RULE CHANGES FOR CONSULTATION

Committee:	Technical Committee
Date of Meeting:	10 July 2019
Closing date for consultation:	23 rd August 2019

Section K – Competitors: Safety

Drawing No. K64

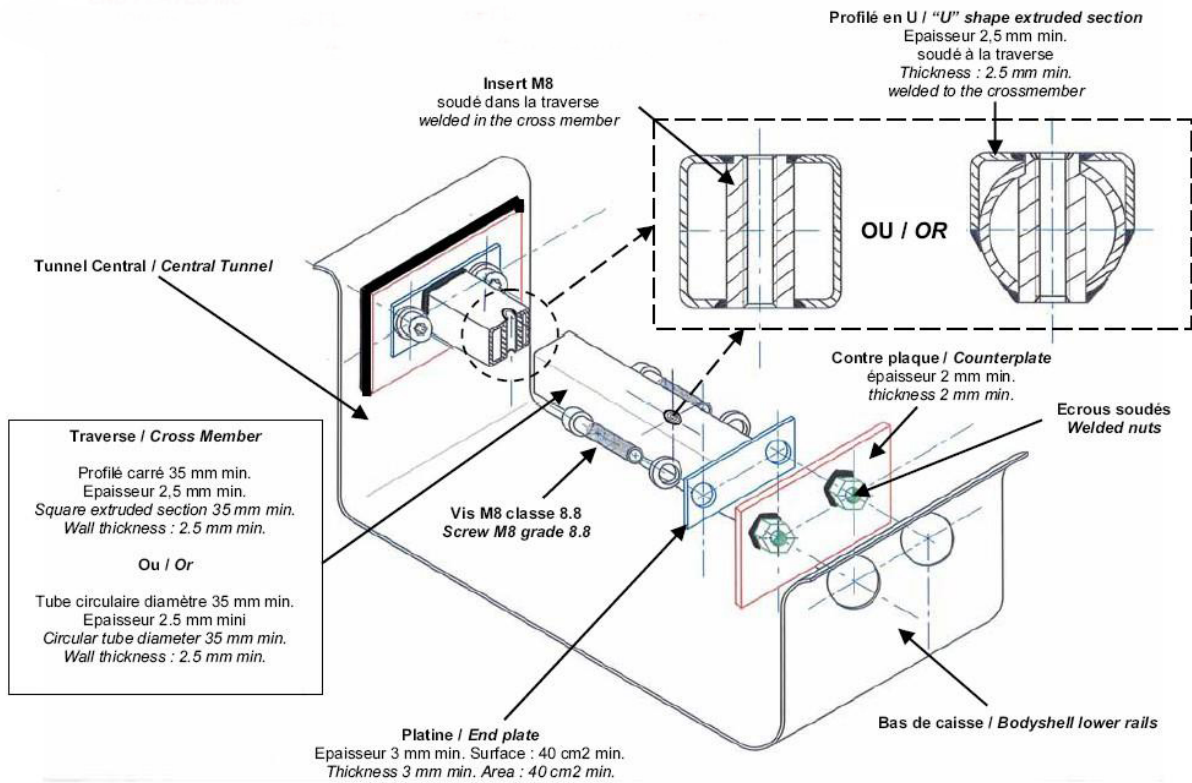
2.2.1. Supports must be attached to the shell/chassis via at least 4 mounting points per seat using bolts with a minimum diameter of 8mm and counterplates, according to drawing No. K32 **or K64. In the case of drawing No. K64 the end plates may alternatively be welded to the counterplate.** The minimum area of contact between support, shell/chassis and counterplate is 40 sq cm for each mounting point. In Series Production Cars manufacturers' standard seat mounting points may be used. If quick release systems are used, they must be capable of withstanding vertical and horizontal forces of 18000N, applied non-simultaneously. If rails for adjusting the seat are used, they must be those originally supplied with the homologated car or with the seat.

Reason: To provide regulations for transverse cross member seats mounts which are currently widely used but not catered for within our regulations. This proposal adopts the FIA regulation and drawing with the exception that we will allow the bar to be welded to the counterplates rather than bolted as the FIA require.
